NUCLEAR FUEL SERVICES, INC.
a subsidiary of The Babcock & Wilcox Company

21G-12-0039
GOV-01-55-04
ACF-12-0066
March 1, 2012

Subject: Response to the NRC Staff Evaluation of NFS Responses to RAIs Regarding Final Status Survey Report for Survey Units 2, 8, 9, 19, and 20, dated May 5, 2011

**Response to the NRC Staff Evaluation of NFS Responses to RAIs Regarding
Final Status Survey Report for Survey Units 2, 8, 9, 19, and 20, dated May 5, 2011**

Figure 1 Location of Pond in SU19

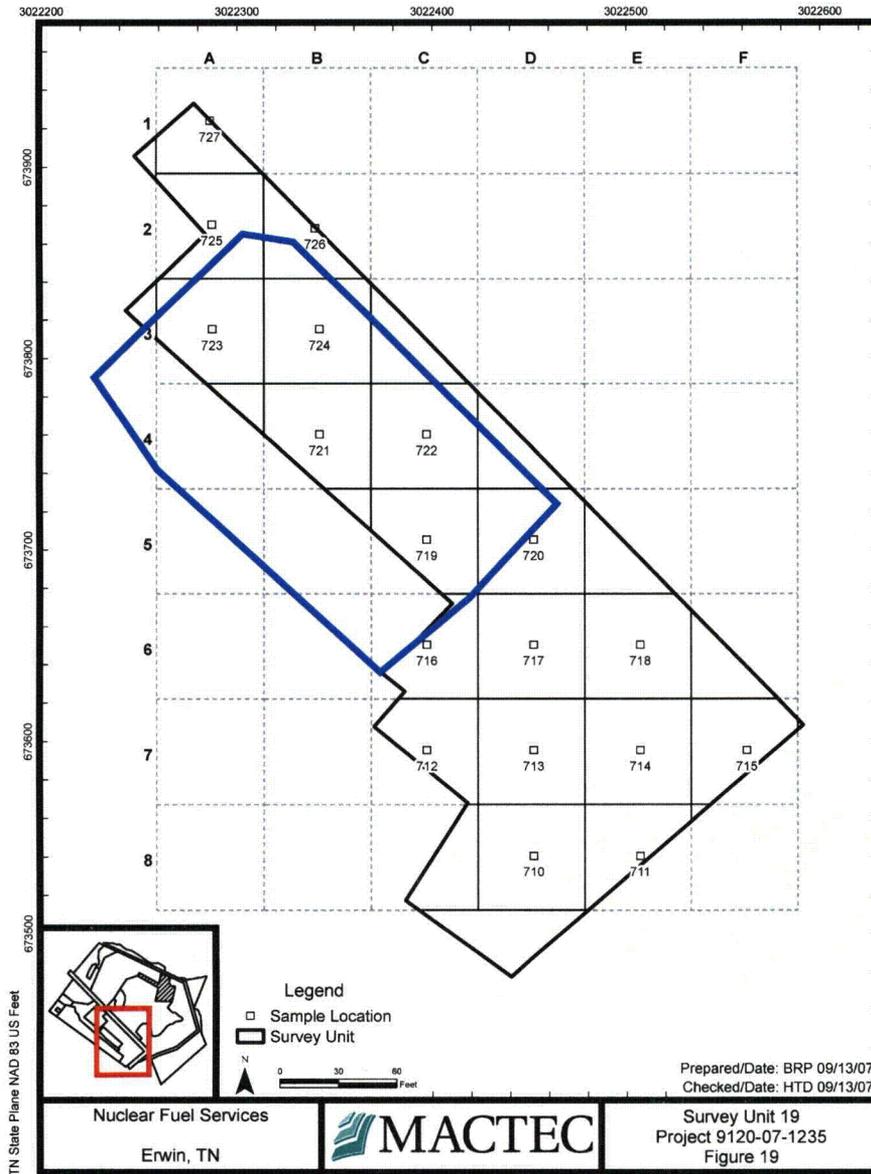
RAI #3: The Selection of Survey Boundaries for Survey Unit 19

NFS will split the survey unit and is asking for NRC concurrence on the following strategy for that survey unit division.

The northwest half of SU19 and the holding pond area are not perfectly aligned. Precisely removing the pond area, outlined in blue in Figure 1 Location of Pond in SU19, would create a number of technical challenges. Precise removal would leave 3 coreholes in the northwest corner of SU19 orphaned from the rest of the SU19 data in the southeast half of the remaining survey unit. The mathematical models used in the approved SubSurface DCGL methodology cannot accommodate groups of samples that are in two different spatial locations. Also, these samples cannot be combined with other adjacent survey units because those units have greatly different corehole spacing. Therefore, NFS proposes that SU19 be split into two distinct survey units using the boundaries shown in Figure 2 Proposed Division of SU19.
